**CITY OF WINTER PARK
PLANNING AND ZONING BOARD**

**Staff Report
March 6, 2018**

SPR 18-03 REQUEST OF WINTER PARK DESIGN FOR APPROVAL TO CONSTRUCT A NEW 5,758 SQUARE FOOT SINGLE-FAMILY HOME LOCATED AT 1234 LAKEVIEW DRIVE ON LAKE VIRGINIA, ZONED R-1AAA.

REQUEST OF VERAX INVESTMENTS, LLC FOR: CONDITIONAL USE APPROVAL TO CONSTRUCT A TWO STORY, 20,000 SQUARE FOOT MEDICAL AND GENERAL OFFICE BUILDING ON THE PROPERTY AT 1111 WEST FAIRBANKS AVENUE, ZONED C-3.

ARCHITECTURAL SITE PLAN

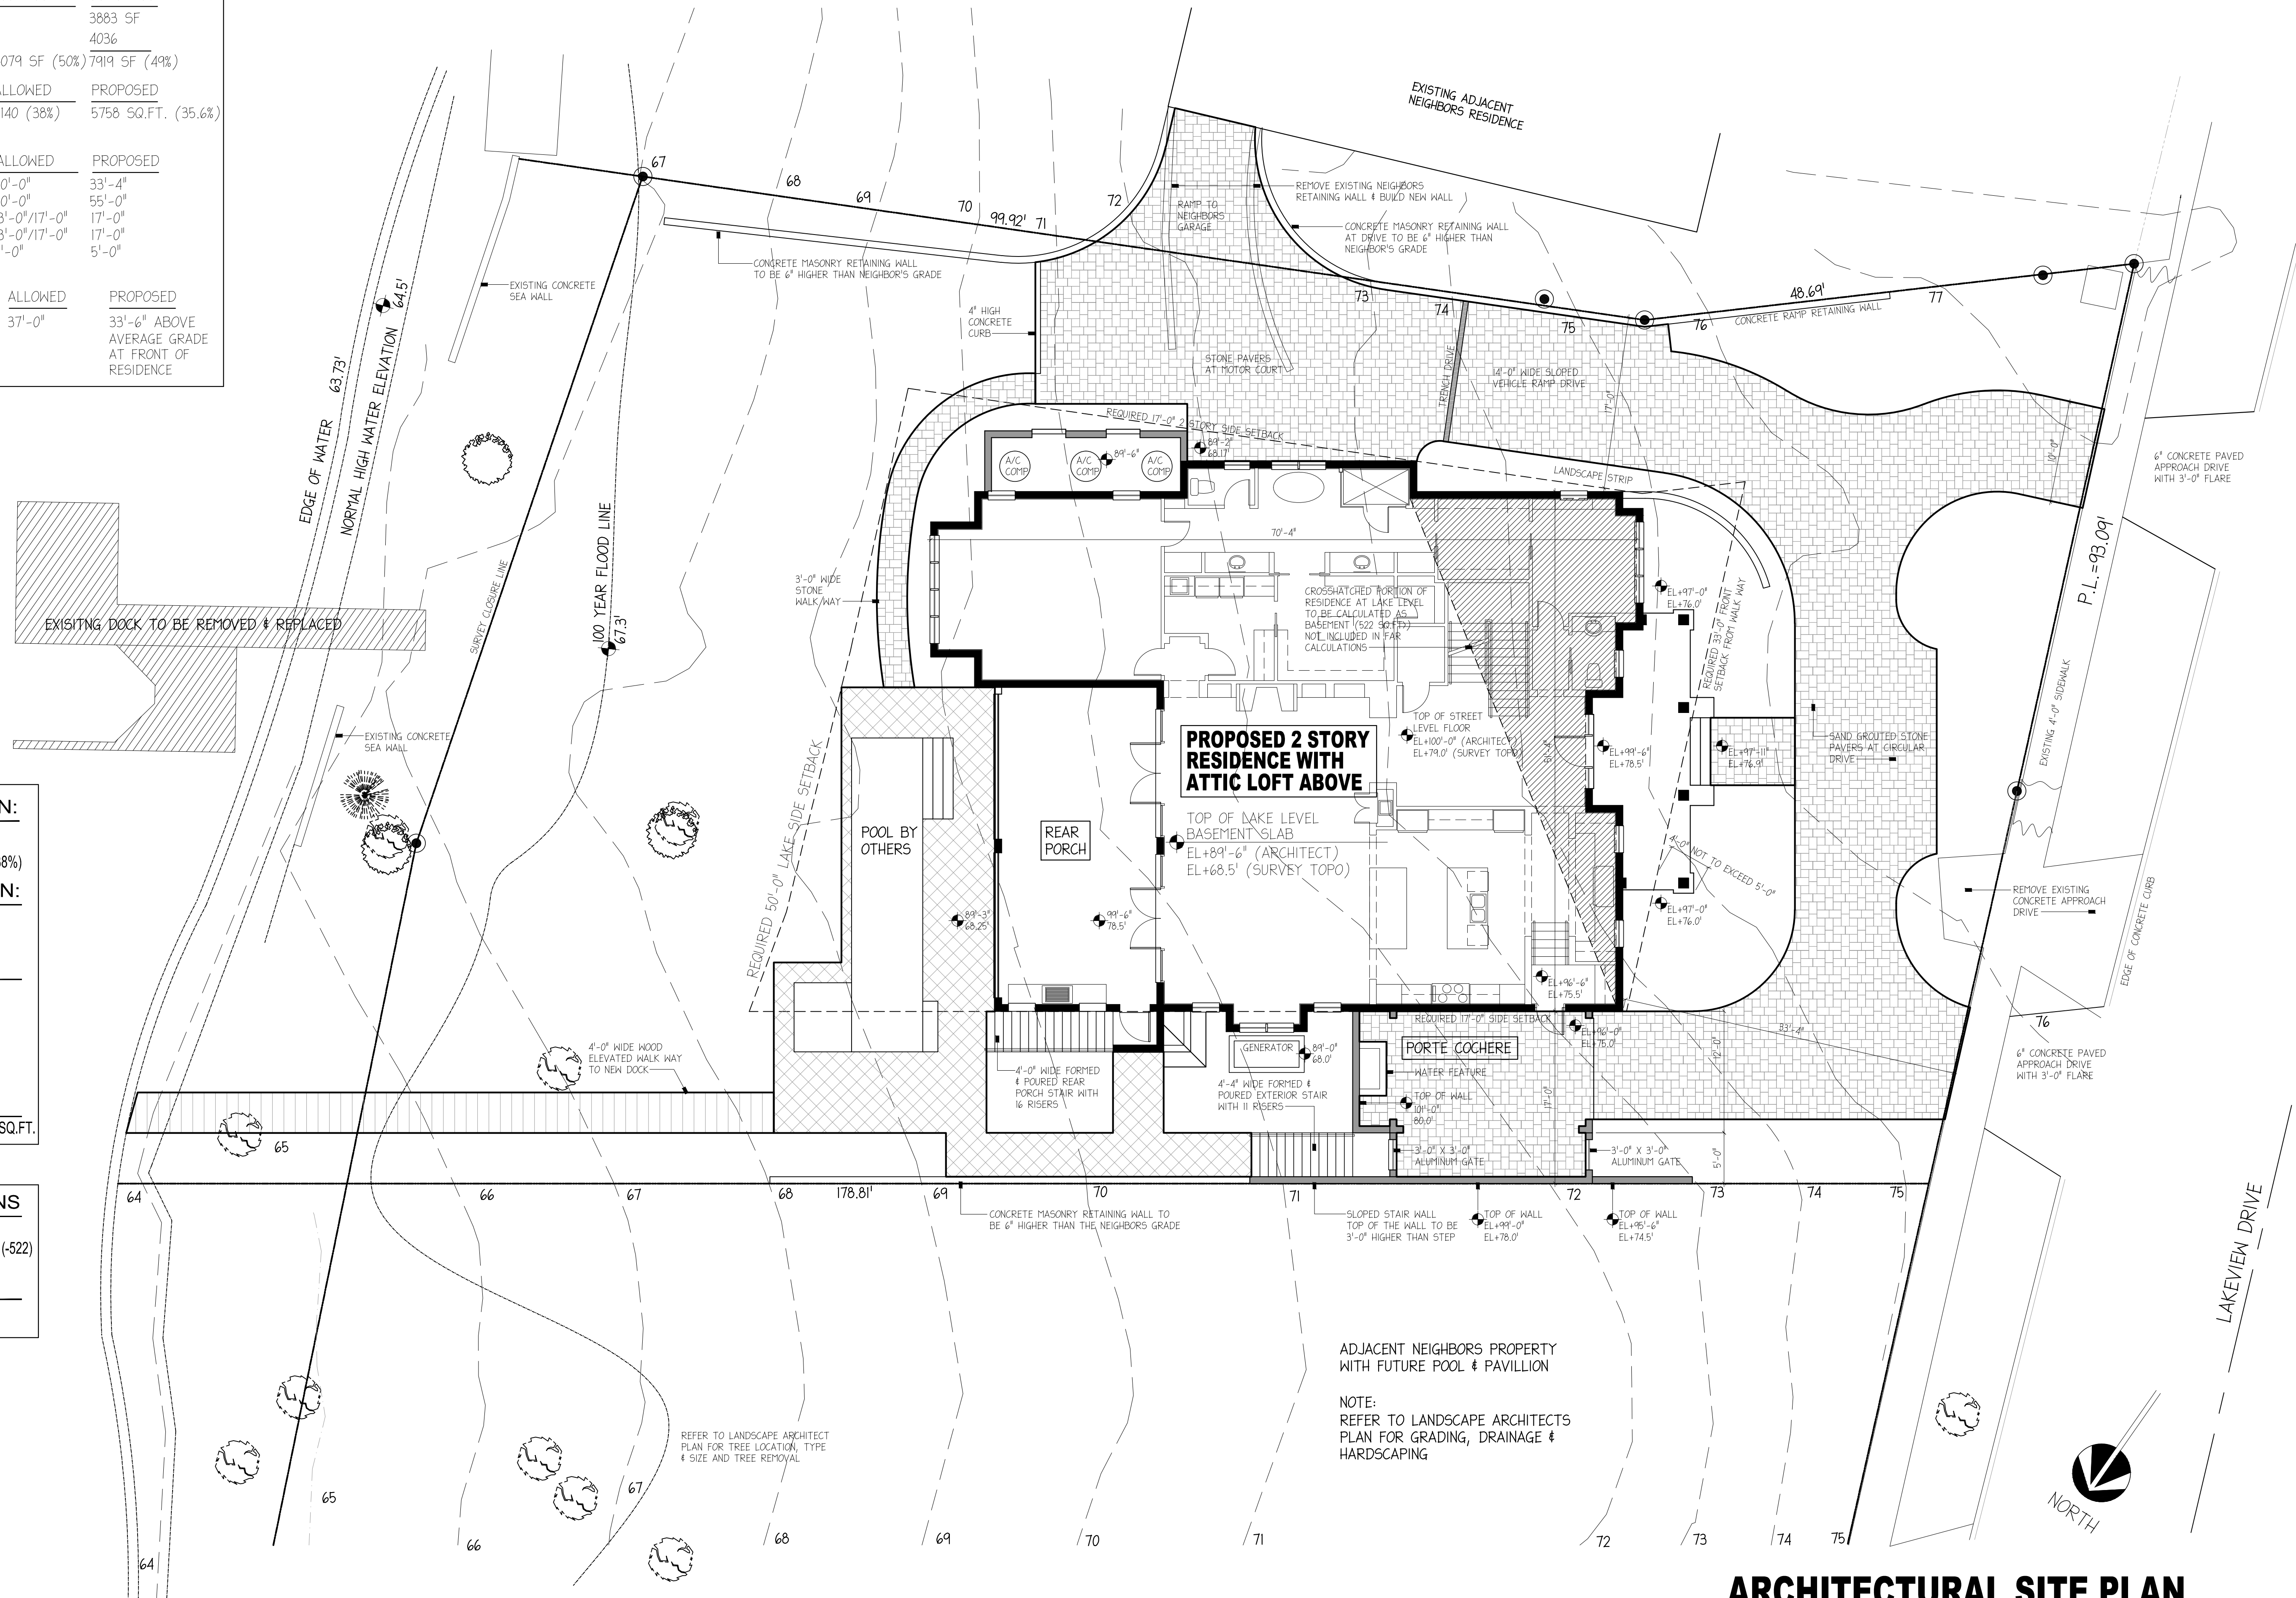
VIEW FROM THE LAKE: The Code direction is to minimize the height and extent of stem walls or retaining walls facing the lake. Generally, the policy is not to permit walls/swimming pool decks facing the lake in excess of three feet in height. This lot has a grade drop from the street to the lakefront of almost ten (10) feet. At the street front this home appears to be a one-story home, and as the lot slopes the second floor is being constructed within that grade drop. Because of this design technique, the issues that we typically deal with about grades and pools decks/retaining walls are not present in this case since the pool is at the same grade as the bottom floor.

VIEW OF NEIGHBORS: The Code direction is to minimize the degradation of traditional views across properties by new houses, additions, second story additions, etc. alongside property lines toward the lake that may block traditional views. This home is being constructed at roughly the same lakefront setback as the south adjoining residence. The north adjoining property is currently vacant, but is in the same ownership as the lot across Lakeview Drive (1251), and is proposed to be developed with a pool and cabana that will also be at the same lakefront setback. The lakefront views of neighbors will not be diminished from this request.

any fertilizers, herbicides, etc. Typically, this retention requirement is accomplished by the creation of a depressed swale area across the waterfront of about one foot in depth. The amount of impervious surface determines the need for the depth of the swale. The applicant is proposing a stormwater retention area that is sized to meet the City's code requirement near the lake edge.
